ATLANTIC YARDS CONSTRUCTION UPDATE  
SUPPLEMENTAL REPORT

This is a Supplemental Report to the previously issued two week look – ahead regarding upcoming construction activities at Atlantic Yards covering the period of August 15 – August 28, 2011

**PROPOSED 16' FENCE AMENDMENT AT DEAN STREET**

**POE 5 SEWER &  
WATER  
CONNECTIONS**

**DEAN STREET POE CONNECTION MPT PLAN**

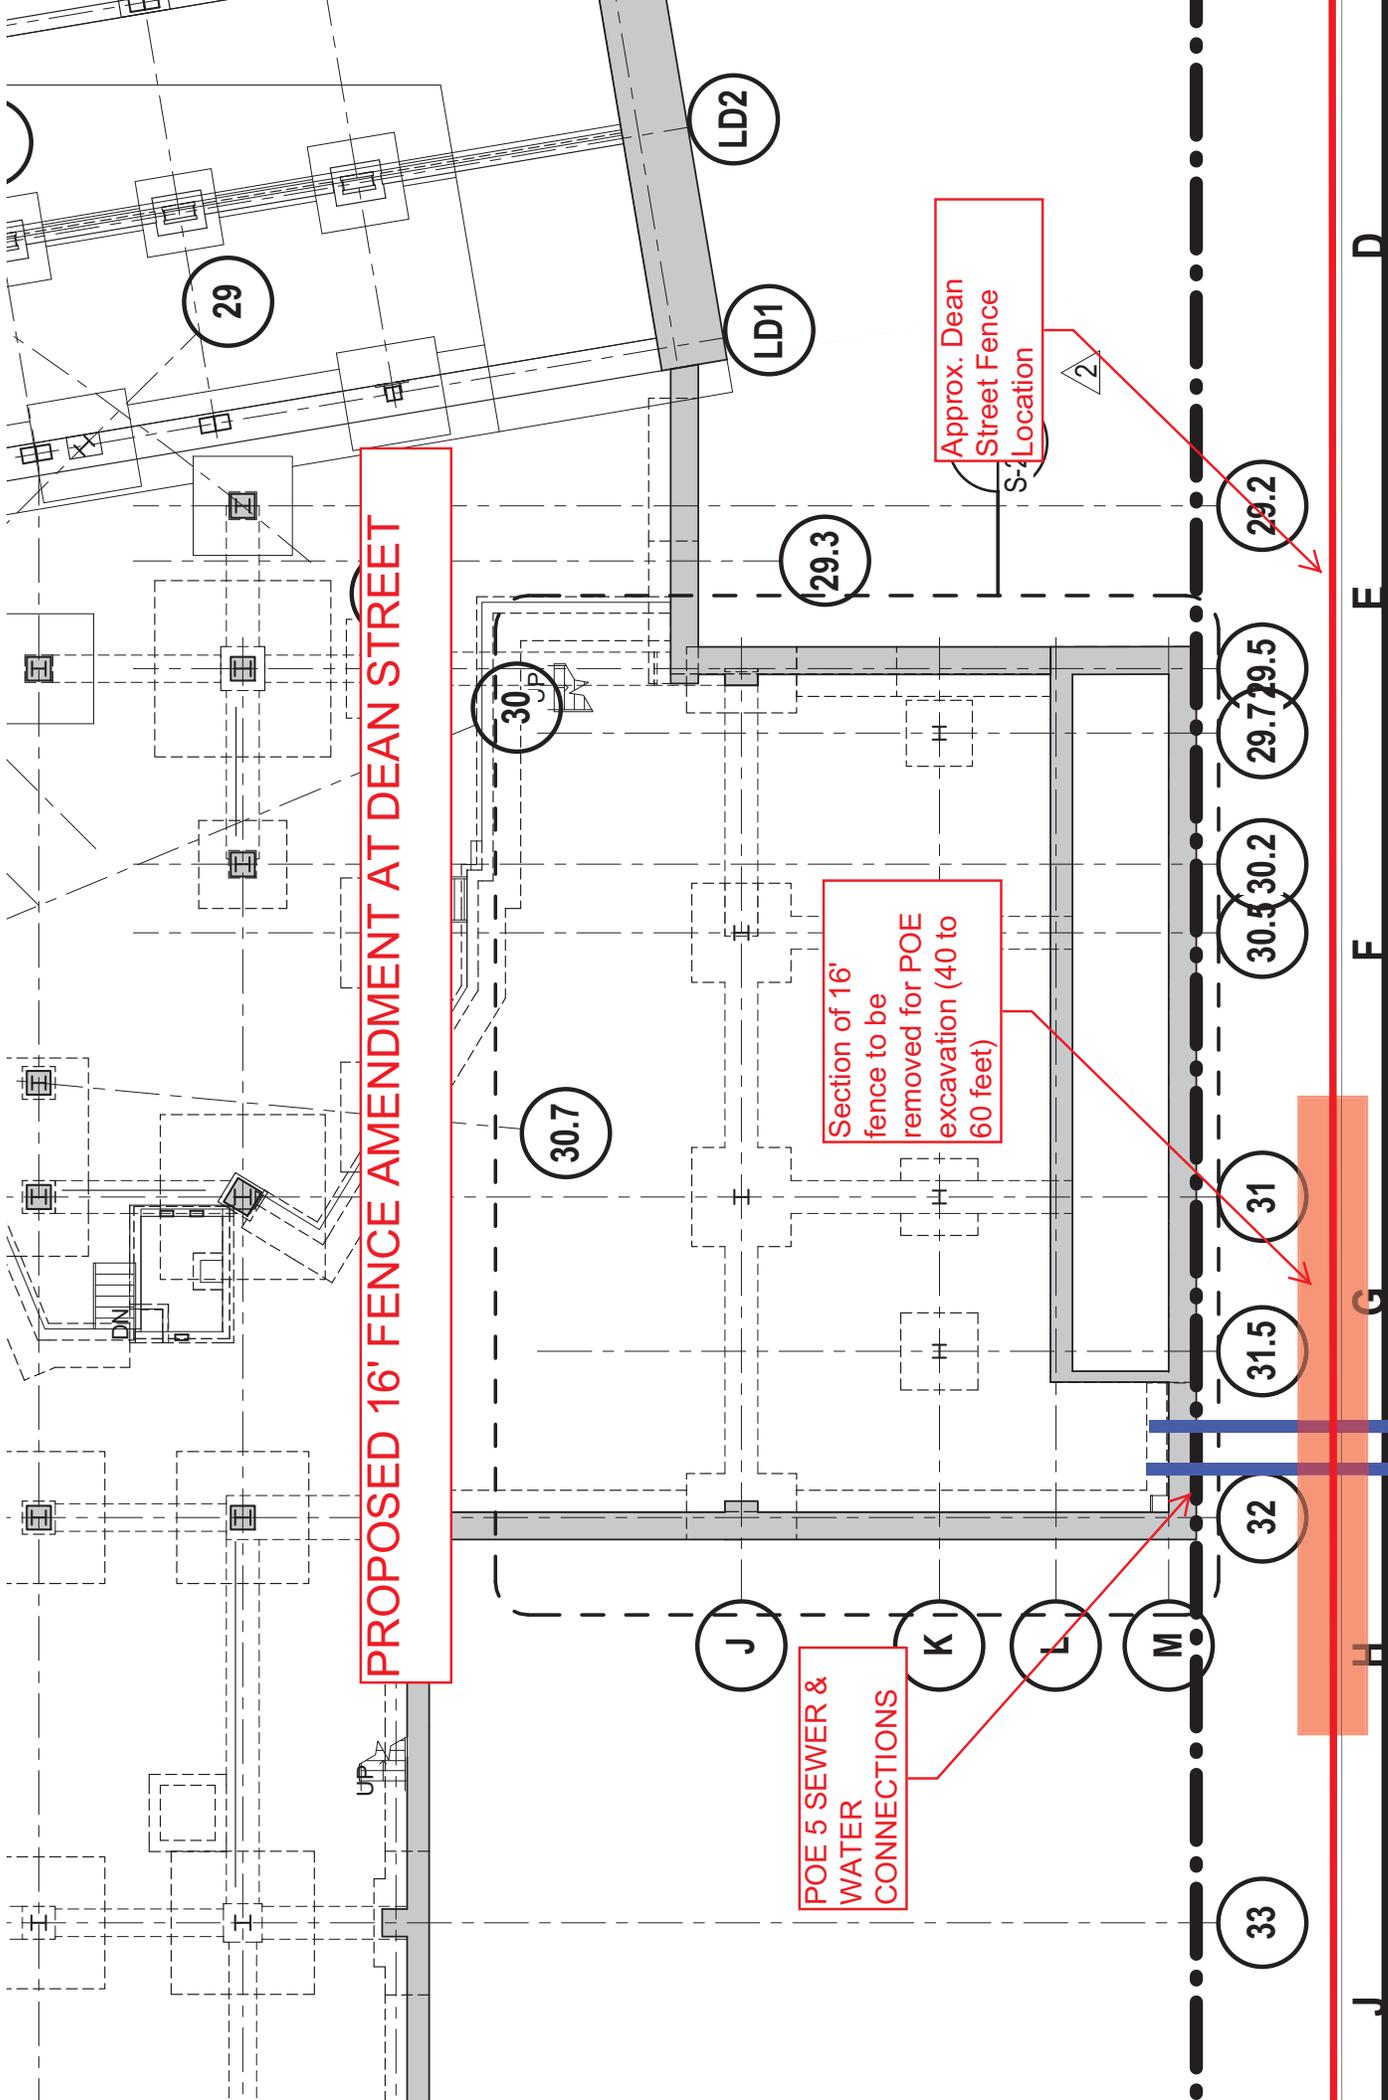
- The MPT plan for this work was approved by OCMC on July 25, 2011 and is attached to this update. The MPT displaces a portion of the bicycle lane. Temporary traffic controls signage will be provided to alert bicycles and vehicles to “share the road”. Some parking on the south side of Dean Street will be removed for the duration of the work.

**NOTES:**  
 1. 8" FIRE SERVICE CONNECTION SHALL BE INSTALLED AT NIGHT. PLATE UTILITY TRENCH DURING DAYTIME HOURS UNTIL COMPLETION.  
 2. TEMPORARY TRAFFIC CONTROL SIGNS TO BE BLACK ON ORANGE SIGN COLOR  
 3. INSTALL "CONSTRUCTION IN BIKE LANE AHEAD PROCEED WITH CAUTION" SIGNS 350' AND 200' PRIOR TO WORK ZONE ON DEAN STREET SIDEWALK BETWEEN 5TH AND FLATBUSH AVE.  
 4. CONTRACTOR TO RE-STRIPE BIKE LANE AND PARKING LANE AS REQUIRED FROM WORK ZONE DISTURBANCE.
